DOCKETED	
Docket Number:	25-BSTD-03
Project Title:	2028 Energy Code Pre-Rulemaking.
TN #:	271535
Document Title:	Recommendation to Simplify Daylight Responsive Control Acceptance Testing Final CASE Team Comment Letter
Description:	Final CASE Team Comment Letter - Recommendation To Simplify Daylight Responsive Control Acceptance Testing
Filer:	Michael Shewmaker
Organization:	California Energy Commission
Submitter Role:	Commission Staff
Submission Date:	7/17/2026 2:42:25 PM
Docketed Date:	7/17/2026

RECOMMENDATION TO SIMPLIFY DAYLIGHT RESPONSIVE CONTROL ACCEPTANCE TESTING

July 17, 2026

Docket No. 25-BSTD-03

Figure 1. Compliant Range of Daylight Dimming Fraction with Respect to Ratio of Partial Daylight Illuminance to Reference Illuminance

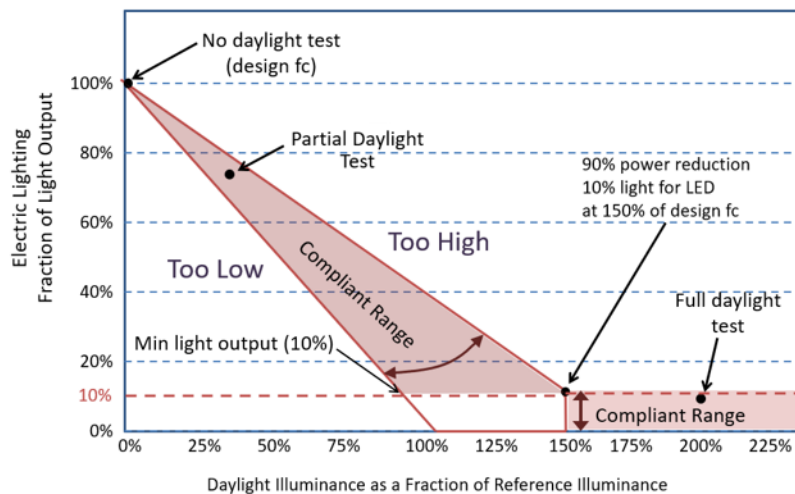
The acceptance range of the proposed test aligns with that developed for the Alternate Partial Daylight Test and is based on the performance of an LED-based system capable of continuous dimming to 10 percent of full power. The proposed tolerances remain unchanged except for the minimum dimming range. The system must be configured to avoid over-dimming, such that the combined indoor daylight and electric lighting illuminance at the reference location is no less than the reference illuminance measured under no-daylight conditions (e.g., at night). The system must also avoid under-dimming, such that the combined daylight and electric lighting illuminance does not exceed a linear dimming trajectory corresponding to 10 percent light output when daylight illuminance reaches 150 percent of the reference illuminance. Figure 1 illustrates the performance characteristics of a compliant control under the proposed Partial Daylight Test.

Figure 2: Compliant Range of Combined Electric Lighting and Daylight (Total Illuminance) as a Fraction of the Reference Illuminance (in Orange)

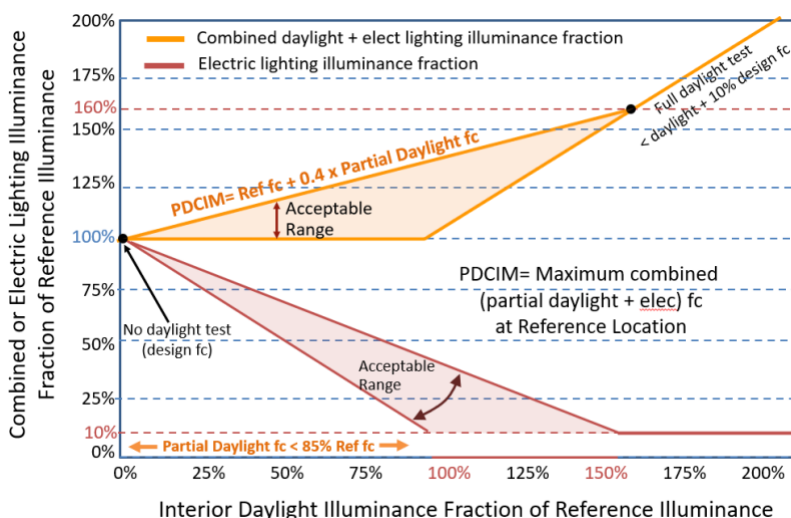
The current daylighting control requirements in Section 601.2.2.4.3 [Section 130.1(d)2C] require that “the combined illuminance from the controlled lighting and daylight is not less than the illuminance from controlled lighting when no daylight is available,” and that “when the daylight illuminance is greater than 150 percent of the illuminance provided by the controlled lighting when no daylight is available, the controlled lighting power in that daylight zone shall be reduced by a minimum of 90 percent.” These requirements are reflected in the equation that defines the upper bound of the acceptable illuminance range. Partial Daylight Combined Illuminance Maximum (PDCIM) is based on a linear interpolation of the combined illuminance from electric lighting and daylight at the Reference Location, from 100 percent of Reference Illuminance when no daylight is present to 160 percent of Reference Illuminance when daylight illuminance at the Reference Location equals 150 percent of Reference Illuminance. At that point, the 160 percent combined illuminance consists of 150 percent daylight and 10 percent electric lighting. Figure 2 presents PDCIM graphically as a function of daylight illuminance normalized to Reference Illuminance.
